From: Jessica Malcolm  
Marine Directorate - Licensing Operations Team  
Marine Directorate  
8 June 2023

Minister for Energy

**APPLICATION UNDER SECTION 36C OF THE ELECTRICITY ACT 1989 TO VARY THE CONSENT GRANTED UNDER SECTION 36 OF THE ELECTRICITY ACT 1989 ON 17 JUNE 2019 TO CONSTRUCT AND OPERATE THE INCH CAPE OFFSHORE WIND FARM, LOCATED 15-22 KILOMETRES EAST OFF THE ANGUS COASTLINE**

**DESCRIPTION OF THE DEVELOPMENT**

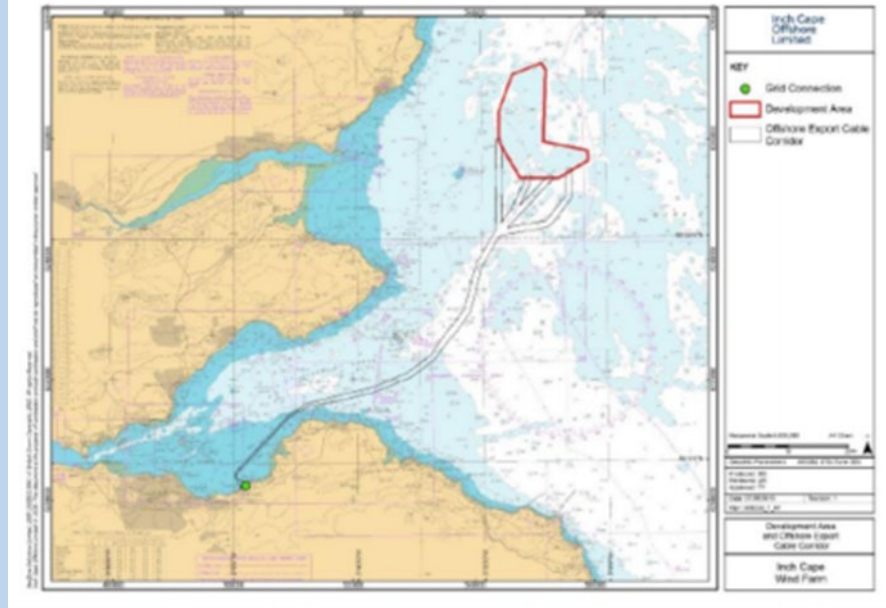
Annex or Condition	Variation
<p><b>In Annex 1 of the Inch Cape Offshore Wind Farm s.36 Consent</b></p>	<p><b>for:</b></p> <p><b>DESCRIPTION OF THE DEVELOPMENT</b></p> <p>An offshore energy generating station, located in the outer Firth of Forth, approximately 15-22km east of the Angus coastline, as shown in Figure 1 below. The offshore energy generating station shall be comprised of:</p> <ol style="list-style-type: none"> <li>1. No more than 72 three-bladed horizontal axis Wind Turbine Generators (“WTGs”), each with:             <ol style="list-style-type: none"> <li>a) A maximum height to blade tip of 291 metres (measured from Lowest Astronomical Tide (“LAT”));</li> <li>b) A maximum rotor diameter of 250 metres;</li> <li>c) A minimum blade tip clearance of 27.4 metres (measured from LAT);</li> <li>d) A maximum blade width of 7.8 metres; and</li> <li>e) A nominal turbine spacing of 1,278 metres</li> </ol> </li> <li>2. No more than 72 substructures and foundations and ancillary equipment.</li> <li>3. No more than 190km of inter-array cabling;</li> </ol> <p>The total area within the Development site boundary is 150km<sup>2</sup></p>

**substitute:**

An offshore energy generating station, located in the outer Firth of Forth, approximately 15-22km east of the Angus coastline, as shown in Figure 1 below. The offshore energy generating station shall be comprised of:

1. No more than 72 three-bladed horizontal axis Wind Turbine Generators (“WTGs”), each with:
  - a) A maximum height to blade tip of 291 metres (measured from Lowest Astronomical Tide (“LAT”));
  - b) A maximum rotor diameter of 250 metres;
  - c) A minimum blade tip clearance of 27.4 metres (measured from LAT);
  - d) A maximum blade width of 7.8 metres; and
  - e) A nominal turbine spacing of 1,025 metres.
2. No more than 72 substructures and foundations and ancillary equipment.
3. No more than 190km of inter-array cabling.
